GREENLANDS NATIONAL GALLERY OF ART
GRØNLANDS NATIONALGALLERI FOR KUNST

INVITED DESIGN COMPETITION
INDBUDT PROJEKTKONKURRENCE

JURY REPORT FEBRUARY 2011
DOMMERBETÆNKNING FEBRUAR 2011

ENTRY 2 10023 WINNER

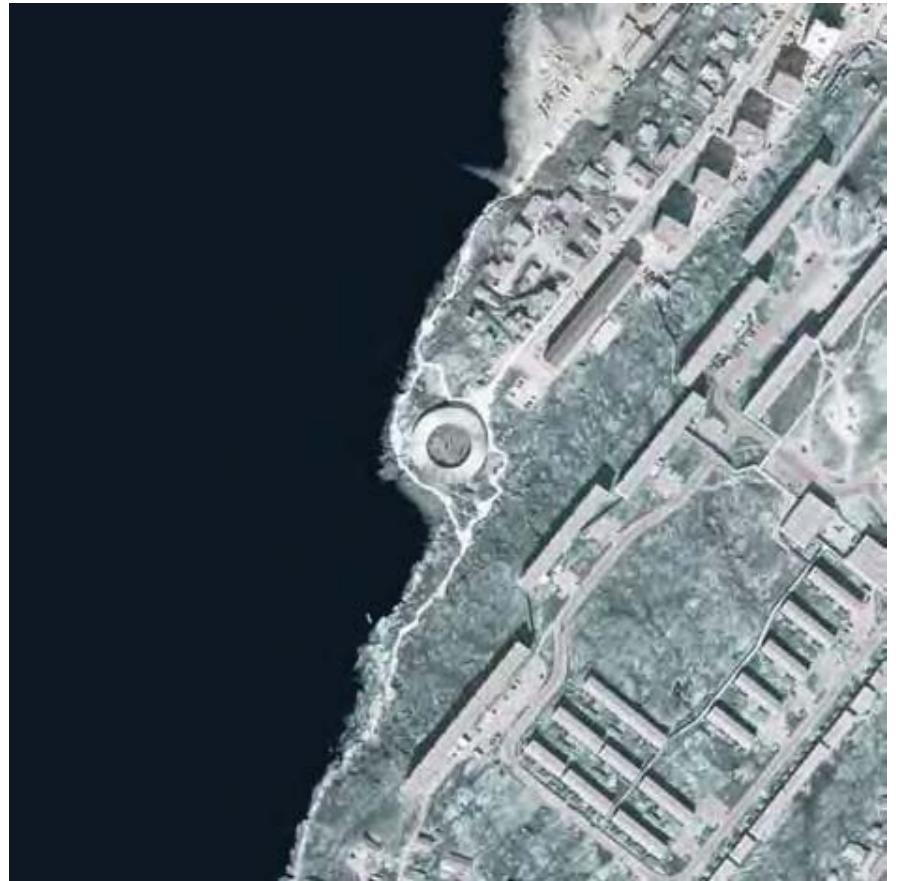
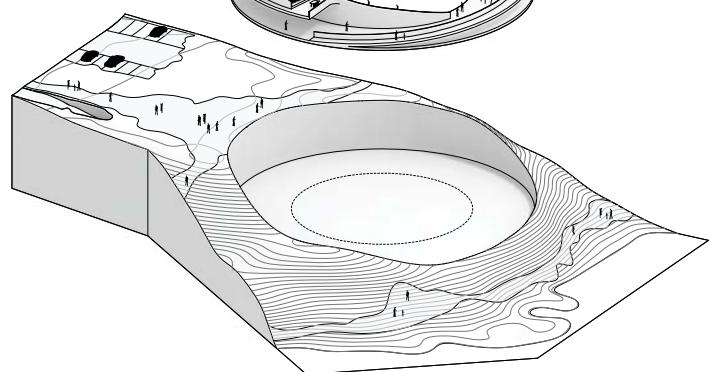
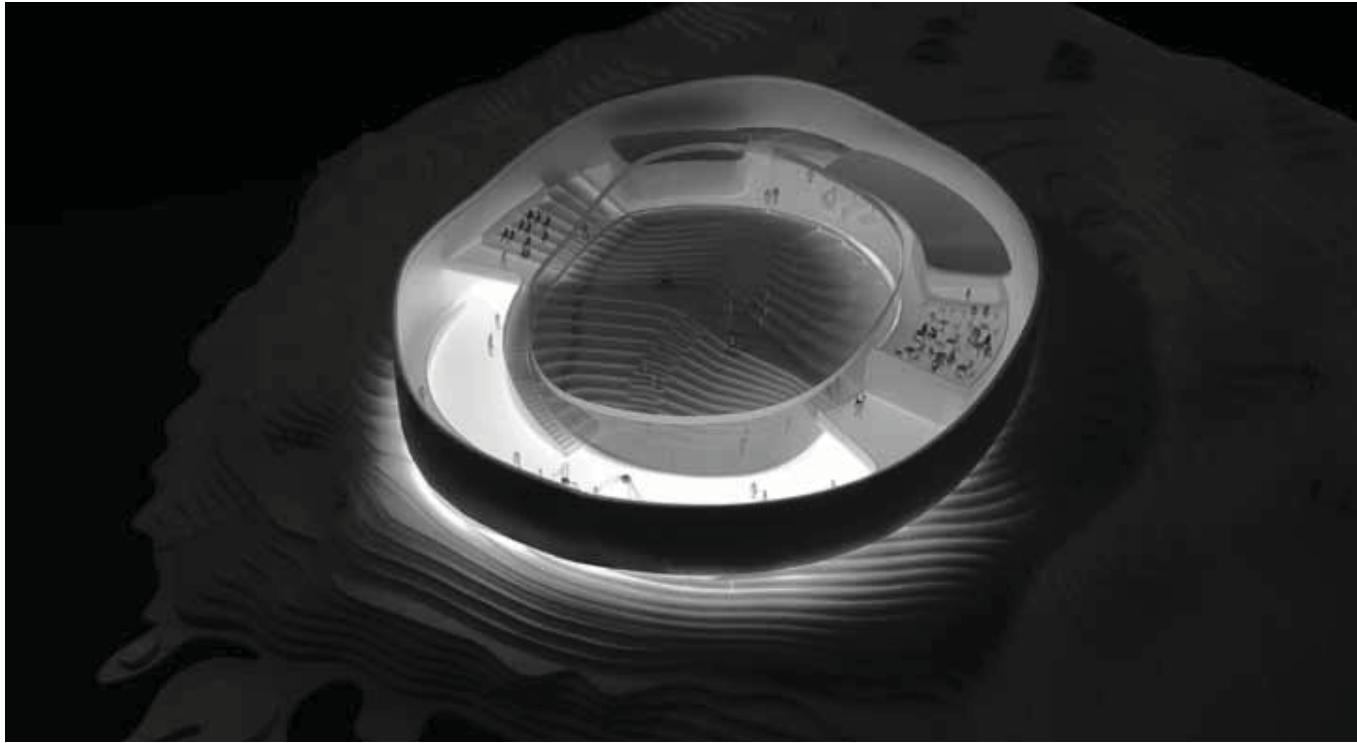
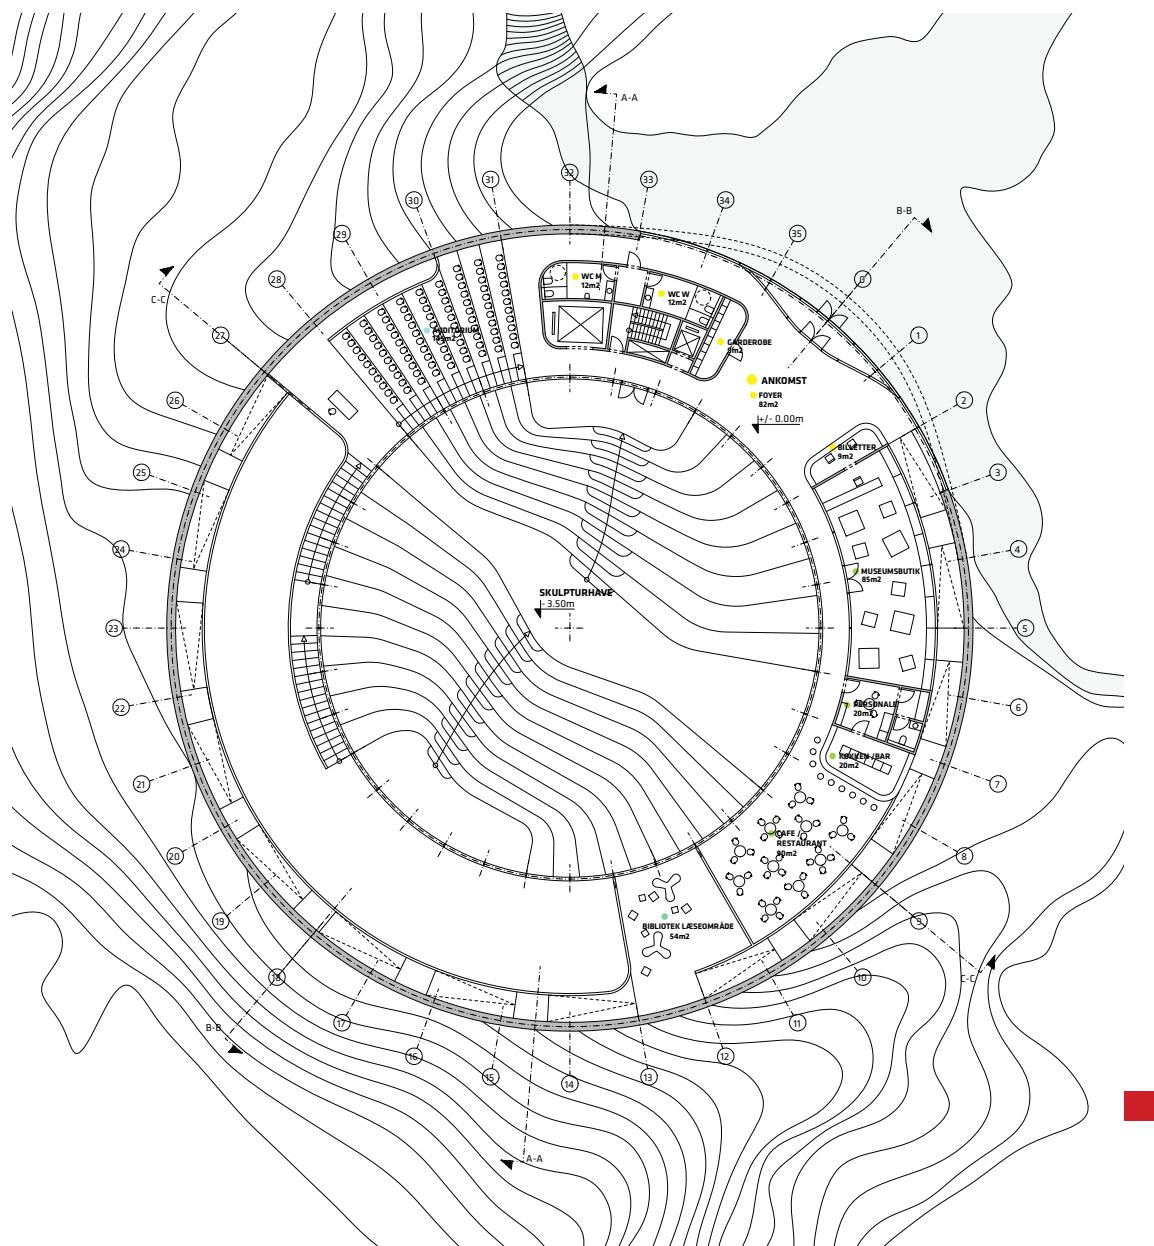
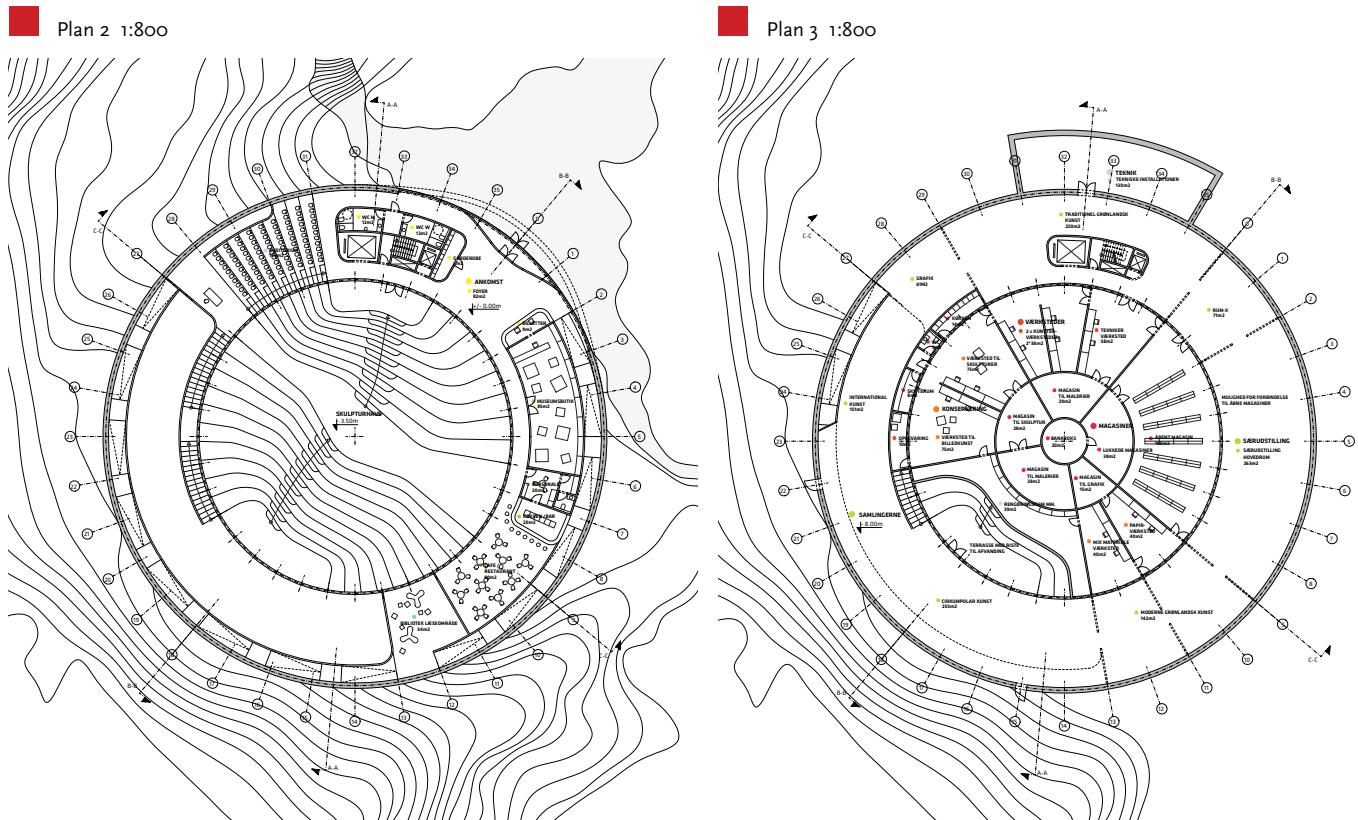
Nothing is without its problems – and here the Jury came up against the inadequate provision for acoustics, the questionable “overhead lights” placed in the risers in the flights of steps in the

sculpture court, the constricted, scarcely functional space under the sculpture court – and last but not least the detriment which traffic on ramps can cause to exhibitions and the peaceful enjoyment which works of art need. In the Jury's opinion the proposal can be revised and adjusted, as the requisite components are in place to sustain reworking into a viable design.

This proposal, which evokes associations with the Hirshhorn Museum in Washington DC, USA, is for a building executed as a circular ring with an outer shell of cast-in-situ reinforced concrete and an inner shell constituted by a glass facade. The roof slab, cast in situ in reinforced concrete, spans from the outer shell to steel columns which support the inner glass facade, which means that the building's exhibition floor is clear of load-bearing structures. The columns of the glass facade seem to be far too fragile and should also be kept clear of the glass in order to reduce cold bridges. The roof slab slopes down towards the fjord but has no transverse falling gradient, which should perhaps be re-worked in order to reduce the volumes of snow falling into the inner courtyard.

The outer shell is internally watertight and insulated, whereas the watertight membrane does not appear to be taken through the ground slab of the building. The solution proposed here to the problem of precipitation of snow in the inner courtyard is a drainage grate at the lowest point of the courtyard space, heated by waste heat from the building, such that the snow is melted and the meltwater led via a large pipe connection under the building and out into the fjord. However there must be some doubt as to whether this solution alone will be adequate to the task of channelling the huge accumulations of snow which can be anticipated in the courtyard space; the freezing/icing over of the discharge pipe must also be expected to cause problems. Thought should be given to incorporating some form of electric trace heating and/or heating elements in the courtyard slab and

pipe in order to provide more certainty in terms of capacity for draining snow away from the inner courtyard efficiently. Work should be done on developing this drainage system into an operationally reliable solution as it will be difficult to service or improve once the building has been taken into service.

The courtyard slab is terraced but appears to have no thermal insulation, as required in its function as building envelope against the rooms below; however this can be rectified without difficulty.

In terms of thermal engineering, the proposed build is described as a "passive house", but this is not borne out in the insulation thicknesses shown in the proposal, which is considered to be far too low. The intention is for heating of the building to be based on low energy systems, heat pump equipment with boreholes sunk in the bedrock (geothermal heat) supplemented by hydro-thermal recovery systems with sea water.

The proposal specifies that the external shell and roof slab will be clad internally with concrete panels; and the floors will be of polished concrete. In terms of acoustics, these surfaces, taken together with the glass facade facing the inner courtyard, are judged to be too "hard" for achieving a satisfactory reverberation time for the room acoustics to feel comfortable. This requires some work in the form of supplementary acoustically attenuating materials in the ceilings and outer walls.

There is no provision for escape routes, a problem which obviously needs to be addressed in the reworking of the proposal.

SNØHETTA OSLO

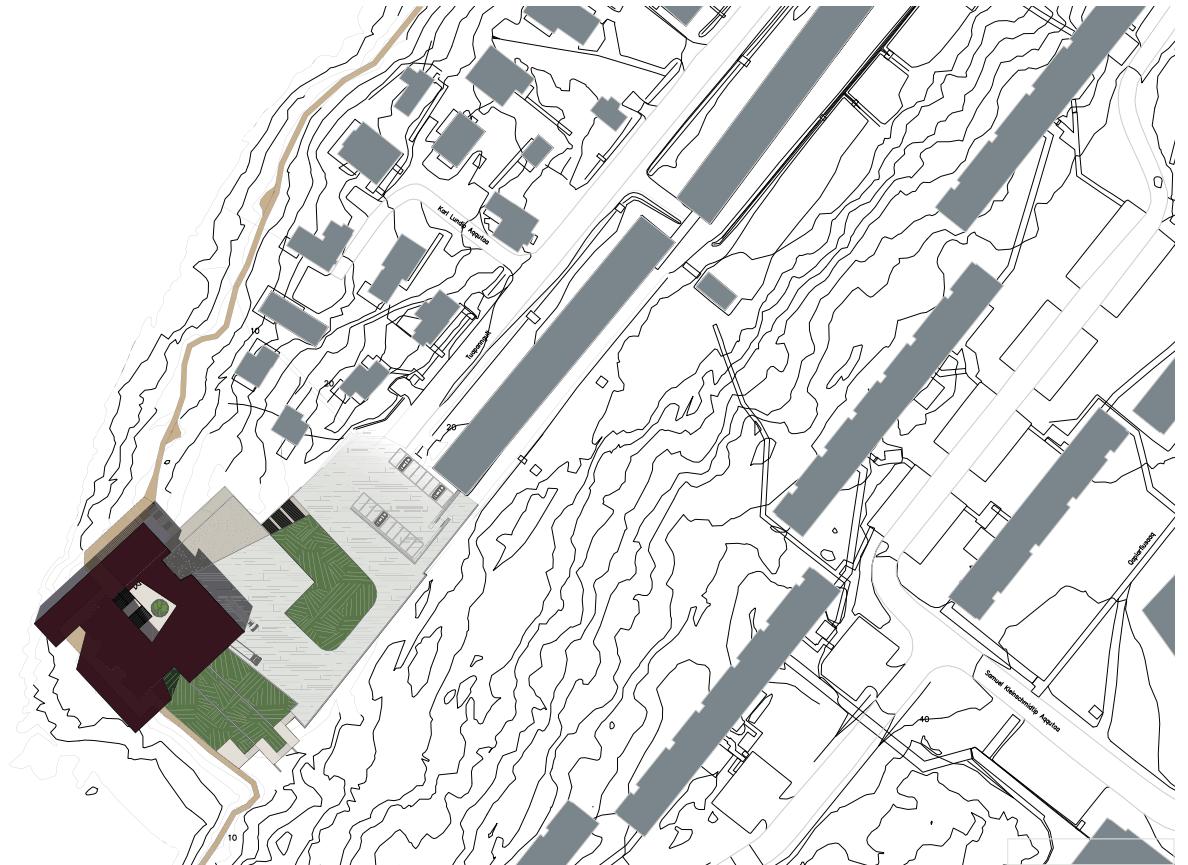
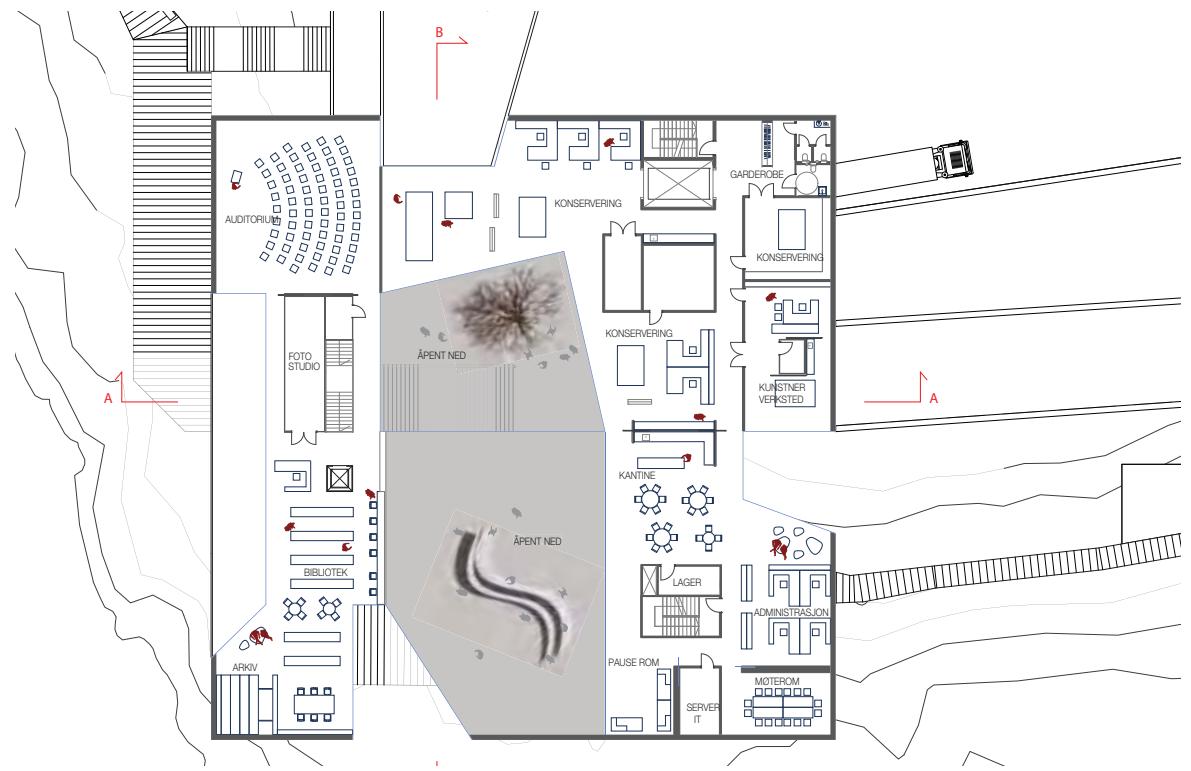
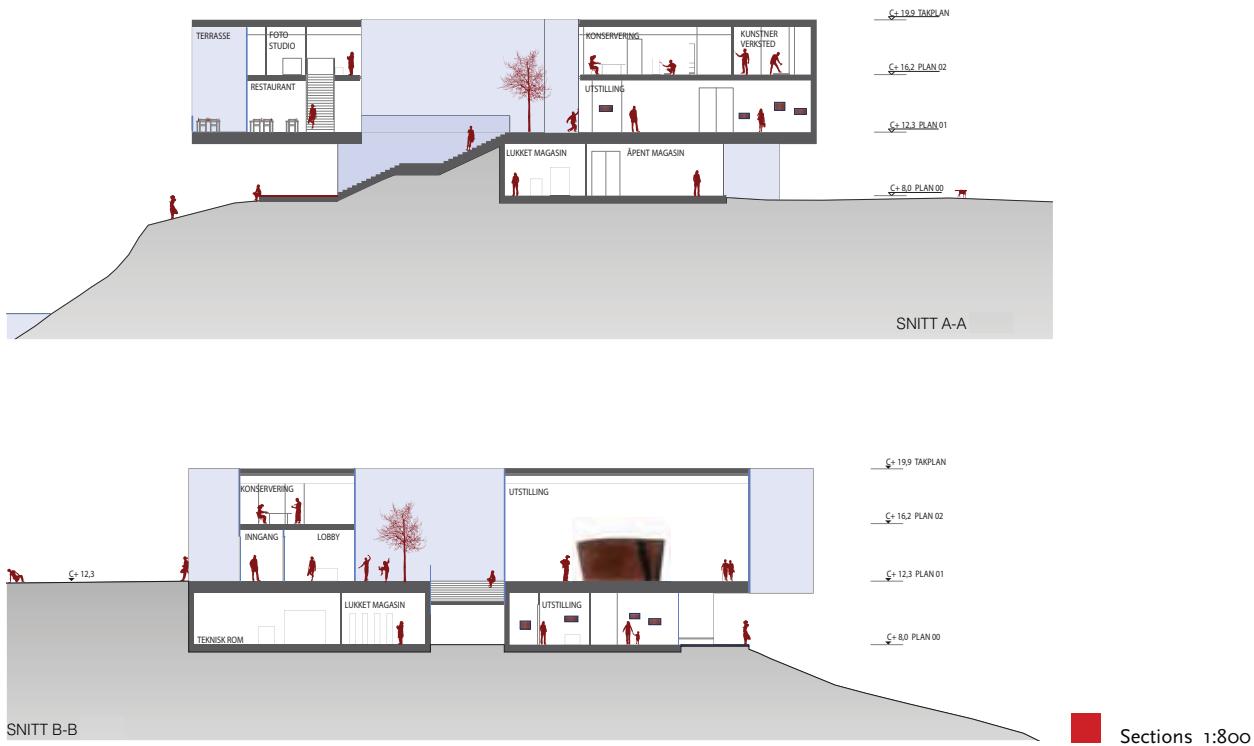
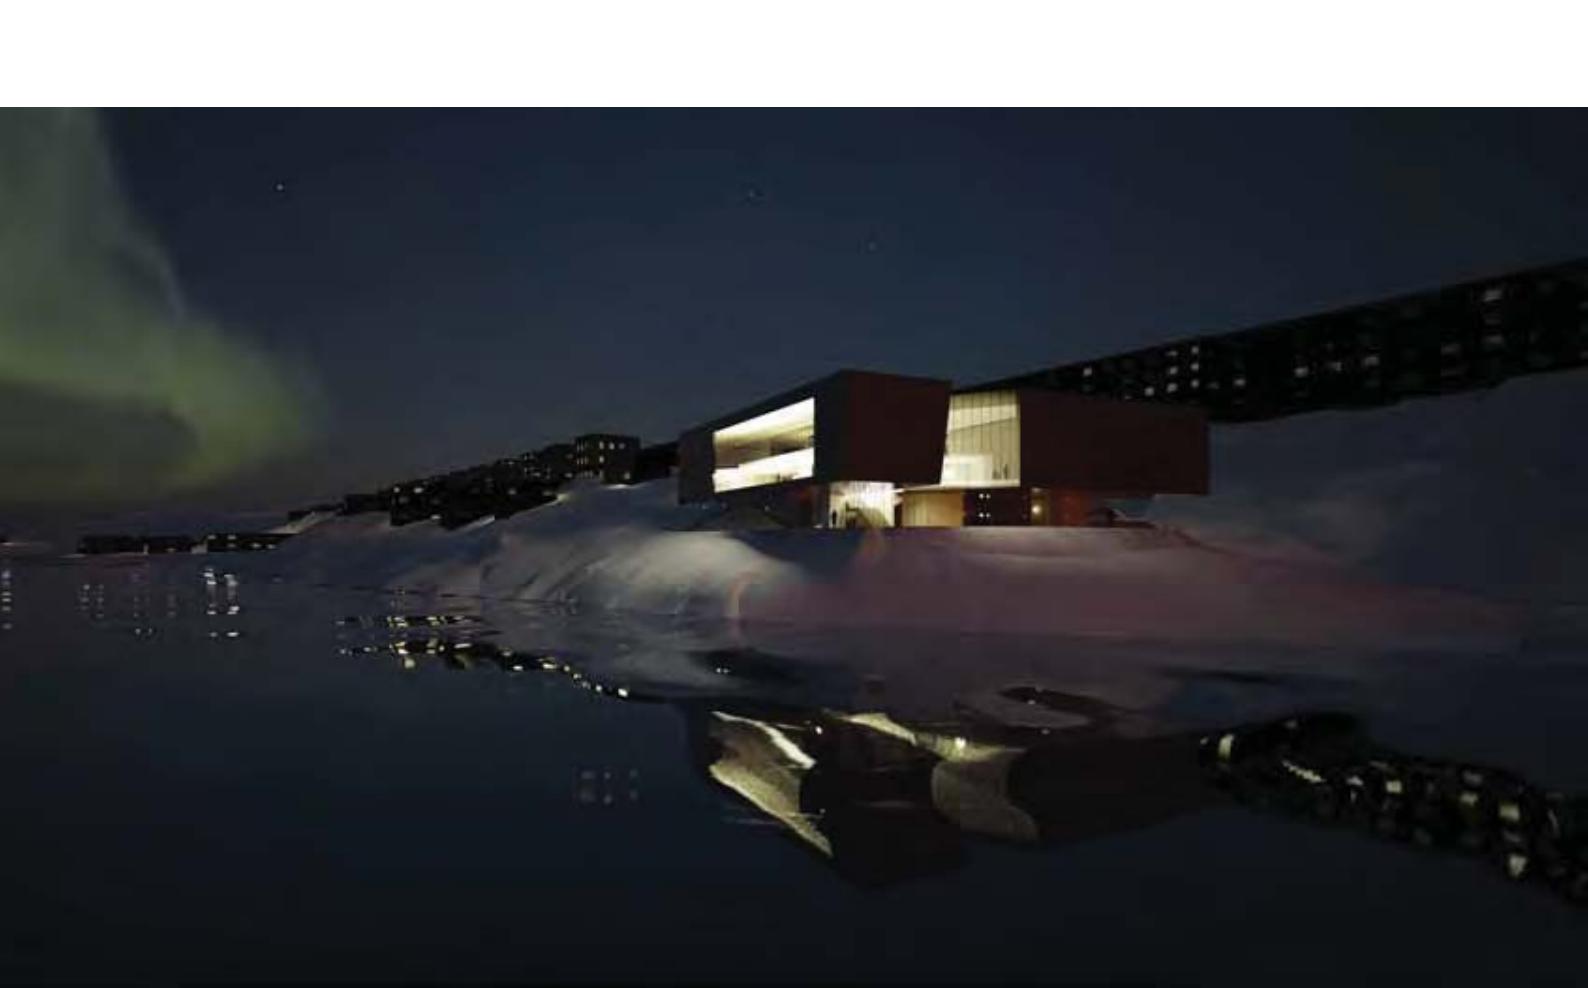
as mirrors and therefore reflect the surroundings on the Gallery. The Jury feels that the refined red glass cladding of roof surfaces and facade is alien to the location and there was doubt as to its ability to withstand the effects of the harsh climate.

This proposal gives a relatively brief structural explanation of how vertical loads will be absorbed by walls and columns cast in situ in reinforced concrete, with suspended floors (plate construction) executed as a combination of prefabricated steel structures and hollow core elements.

The huge cantilevers of the plate construction are not judged to be structurally well examined; the slab thicknesses appear to be on the low side; and it is doubtful whether the lightness of the design can readily be achieved following the requisite detailed structural reworking. The proposal indicates a "flat roof" but makes no allowance at all for the requirements of the Building

Regulations for a minimum roof pitch of 7 degrees. This calls into question whether the proposal's claim to provide a line of sight from Tuapannguit over the building can be achieved. The proposal does not give details of how the foundations of the building will be achieved on made-up ground.

The materials chosen necessitate acoustic measures being taken, those specified being acoustic pendant lamps and furnishings incorporating acoustically attenuating materials. However, the judgement is that these will not suffice for achieving a satisfactory acoustic environment.

The proposal incorporates striking niches, a large inner atrium and a large double-height space outside, in front of the restaurant but provides no explanation of how snow and meltwater can be drained away from these spaces.

The proposal describes the facades as glass facades in tinted glass with a high-lustre polish or glass with silk screen prints. Such glass facades are not felt to be suitable for a build in an area so beset by particle pollution and storms. Nor is the thinness of the transparent glass facades thought to be sufficiently strong or firm to withstand the high velocity load from the action of the winds. Nevertheless, it is deemed that the proposal is capable of being worked up to satisfy the requirement specified in the competition brief for a design "of a high technical standard".
